County of Fairfax, Virginia

STAFF REPORT

APPLICATION PCA/FDPA 2012-MV-007
Waiver #5224-WPFM-002-1

ACCOTINK VILLAGE

SHEET 1 OF 18

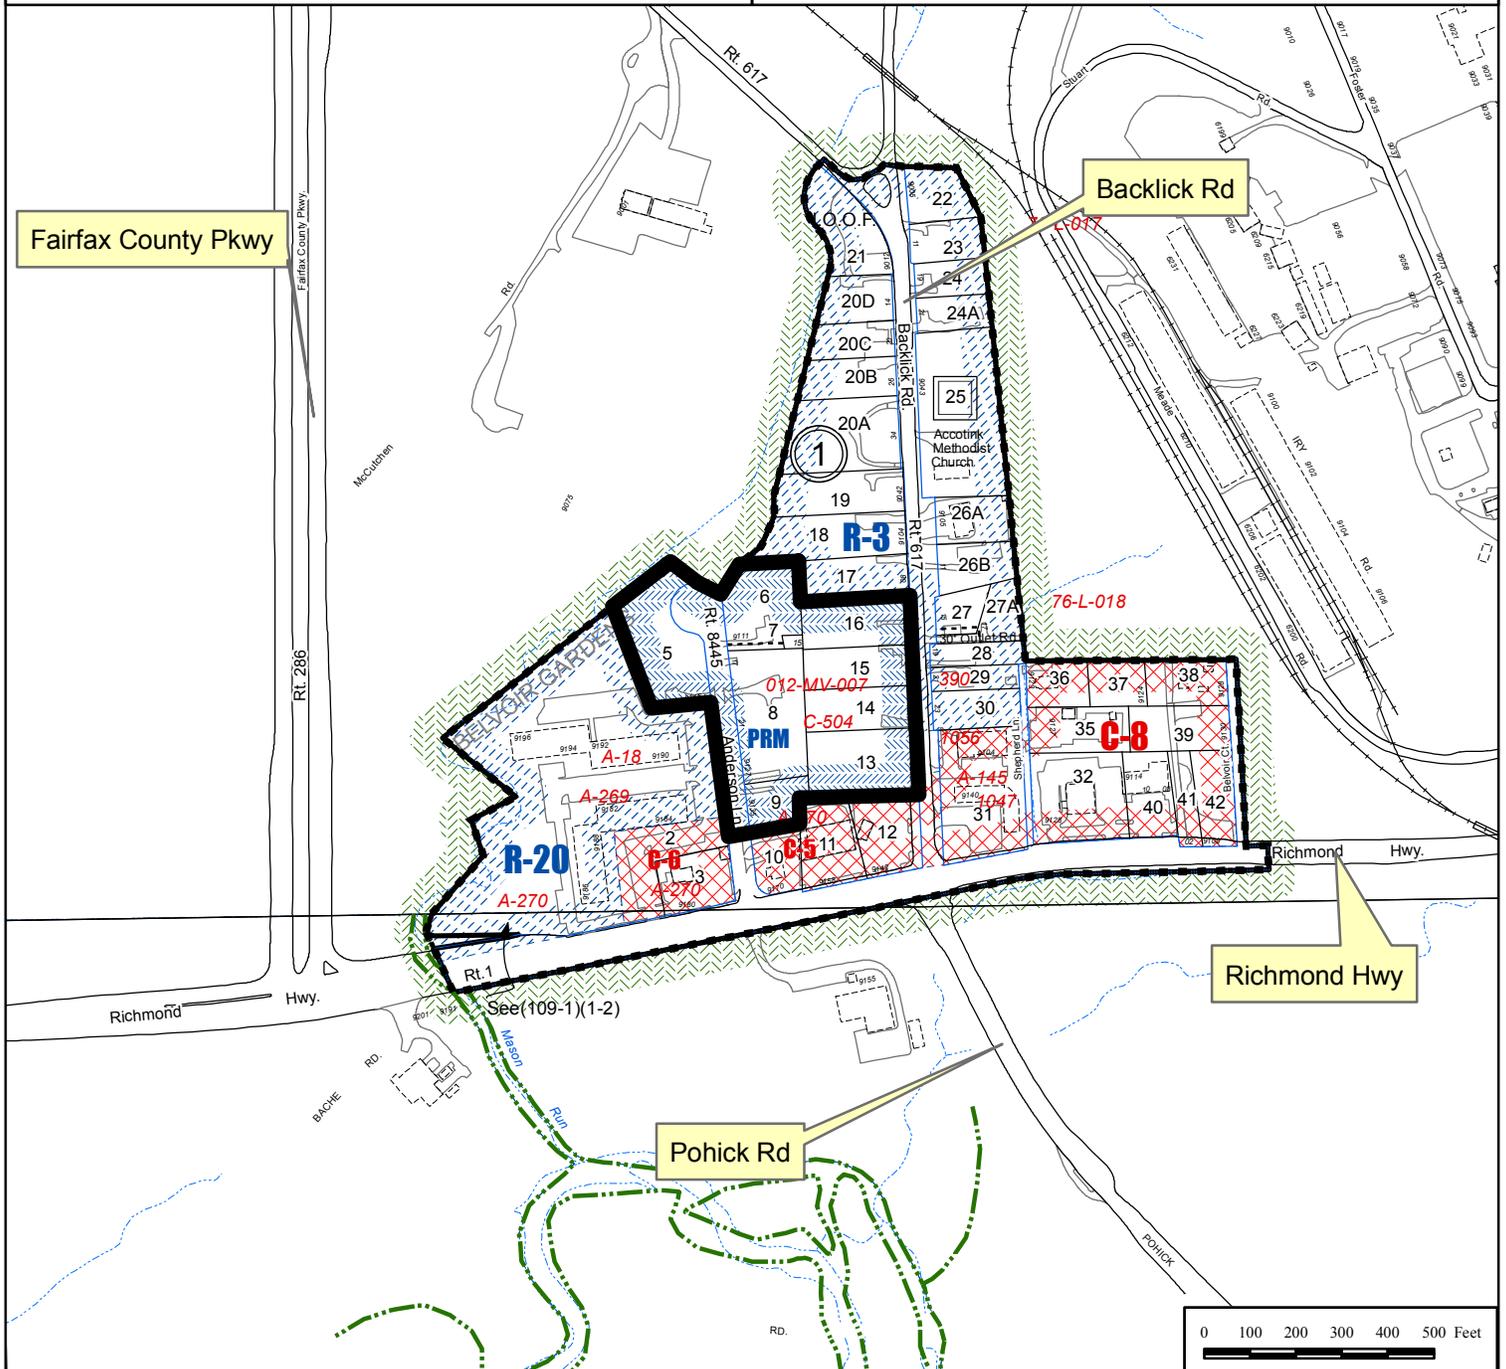
- Comment:** Under the Notes section on sheet 1, item 17 (now item 20), the request to waive the barrier requirement along the property lines with lot 109-1((1)) 18 and a portion of lot 109-1((1)) 17 does not meet the intent of the County's Zoning Ordinance §13-302.*

PROPOSED TYPICAL SECTION - BACKLICK ROAD
SCALE: 1" = 5'
(TO BE USED IF VDOT MODIFICATION REQUEST IS APPROVED)

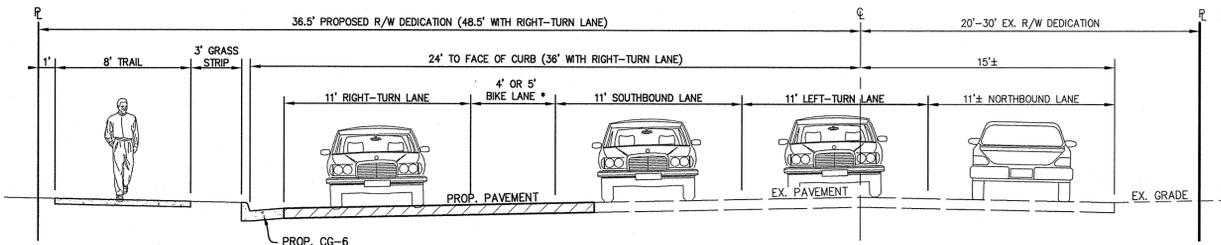
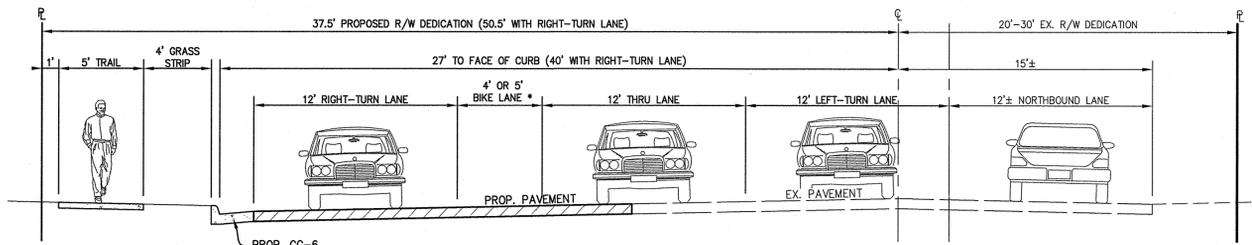
The applicant will be required to obtain waivers from VDOT along Backlick Road for the 11-foot wide lanes and 3-foot wide landscape strip. Staff requested that the applicant apply for these waivers during the zoning process to determine if the streetscape along Backlick Road will be feasible. The applicant has not yet secured approval of these waivers at the time of publication of this report. However, the CDPA/FDPA depicts an alternative section along Backlick Road as previously discussed that would be provided in the event that VDOT does not approve the necessary waivers to provide this streetscape. This alternative proposes 12-foot wide lanes on Backlick Road, a 4-foot wide grass strip, and a 5-foot wide trail and is generally consistent with what was shown with the previous approval in 2013. Staff also noted that VDOT may not maintain the proposed 8-foot wide concrete trail along Backlick Road because it does not meet all of VDOT’s Road Design Manual requirements, which require concrete trails to be a

17. Backlick Road Streetscape. The Backlick Road streetscape shall include landscaping and other elements as shown on the CDPA/FDPA, provided the necessary design waivers are approved by VDOT. In the event that VDOT does not approve the design waivers, the Applicant shall provide the streetscape alternative shown on Sheet 7 of the CDPA/FDPA. In the event that VDOT or DPWES does not agree to maintain the trail along Backlick Road, the Applicant shall maintain this trail.
